Service Bulletin

Bulletin No.: 23-NA-073

Subject: Evaporative DTCs P0442, P0446, P0455 or P0449, Caused by Dust Intrusion into the Evaporative Canister and Canister Vent Solenoid

6325318

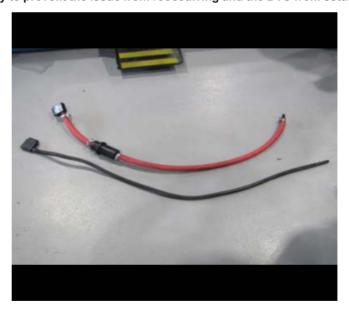
Note: The retro-fit to add the filter is described in the Service Procedure below. For the retro-fit, the filter assembly P/N (with the 3 parts shown above) will need to be utilized along with a 3/4" to 5/8" hose connector that can be obtain for a local parts store. If a vehicle has already undergone the retro-fit and the vehicle returns after a period of time with the Condition reappearing, the filter assembly can be changed.

A filter may be installed between the EVAP canister and air inlet, to correct this Condition. An example of the original, and the retro-fit, evaporative emission canister vent hose are shown in the graphic above.

5041593

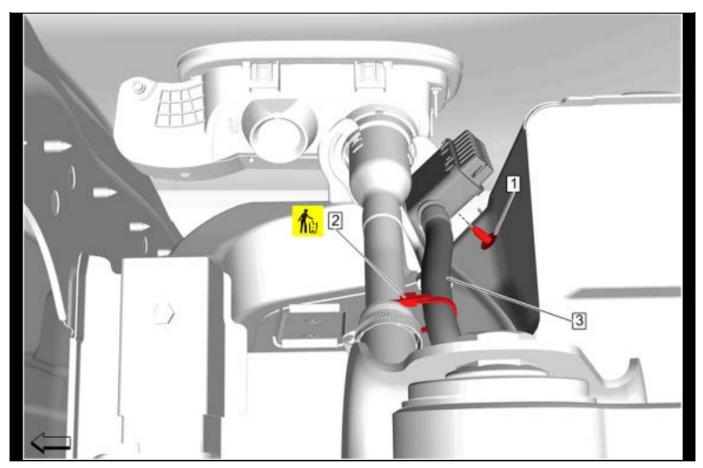
1. Raise and support the vehicle. Refer to *Lifting and Jacking the Vehicle*, in SI.

2. Remove the evaporative emission canister vent hose (3). Refer to the appropriate *Evaporative Emission Canister Vent Hose Replacement (Filler Pipe to Pipe)*, in SI.

6325322

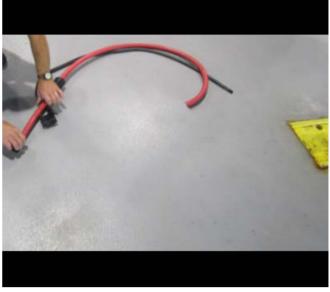
3. Cut the vent hose at the end of barbed fitting on the pre filter (1).

6325326

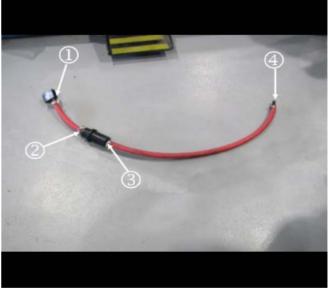
Using the length of the original black corrugated hose as a measurement, cut a length of 3/4 in. diameter heater core hose the same appropriate length.

6325328

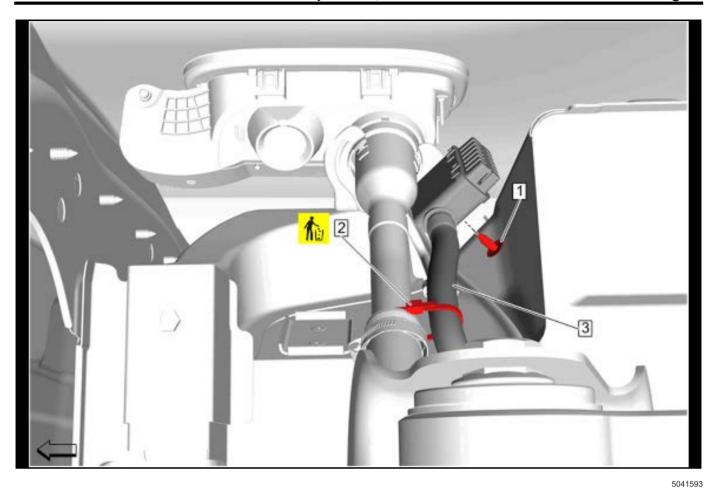
- 6. Secure the 12 inch (30.5 cm) length heater core hose to the fitting on the pre filter (1), using a hose clamp.
- 7. Secure the in-line filter (2) to the other end of 12" (30.5 cm) length hose, using a hose clamp.
- 8. Secure the longer heater core hose to the fitting at bottom of in-line filter (3), using a hose clamp.
- 9. Insert 5/8" male to male fitting (4) into heater core hose on CVS side, using a hose clamp to secure.

6325331

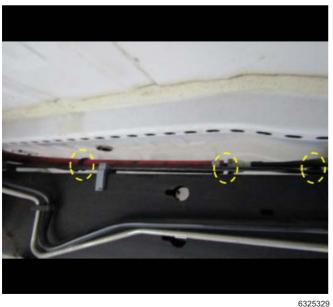
10. Connect 5/8" end of male fitting to the quick connect on the CVS jumper line and install the evaporative emission canister vent hose (3), to the vehicle. Refer to the appropriate Evaporative Emission Canister Vent Hose Replacement (Filler Pipe to Pipe), in SI.

- 11. Using existing hose clips, and tie straps, clip new hose at same location as previous line.
- 12. Lower the vehicle.
